Errors add to confusion!

App G LVIA Addendum - 7.0 Morrisons Gap Rd Upgrade, Page 30

Figure 17. Morrisons Gap Road Upgrade (Not to scale, Map Source: ESRI Imagery 2022)

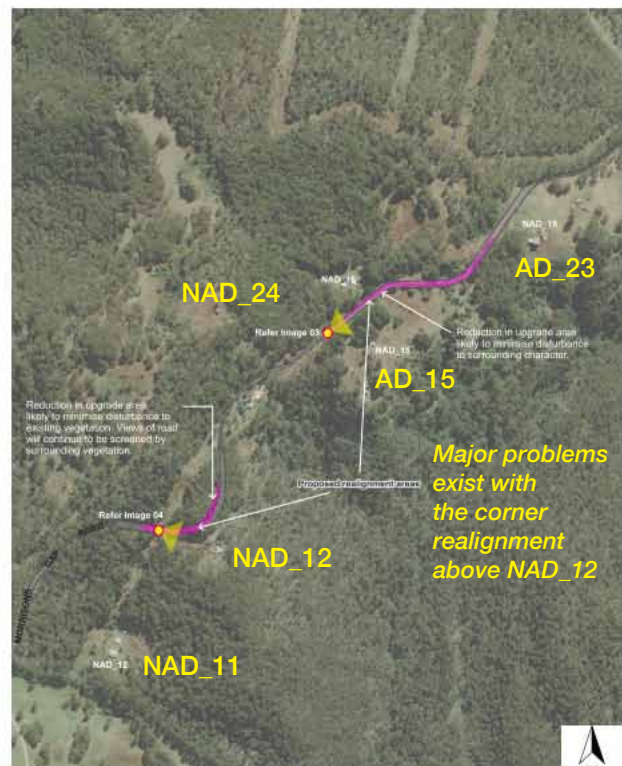
Mistakes with NAD and AD numbers adds confusion and reflects several other errors and obfuscation in the Amended DA documentation.

NAD_18 should be AD_23

NAD_15 should be AD_15

NAD_12 is shown incorrectly at NAD_11 location

NAD_12 & NAD_24 are not marked

This section involves a creek crossing but there is no indication whether a new bridge is required. Also two power poles may need to be relocated. The proposed layover for OSOM vehicles is not shown on Image 04 or Figure 17. Placement of a layover in a section of road passing through a lifestyle property subdivision is not appropriate.
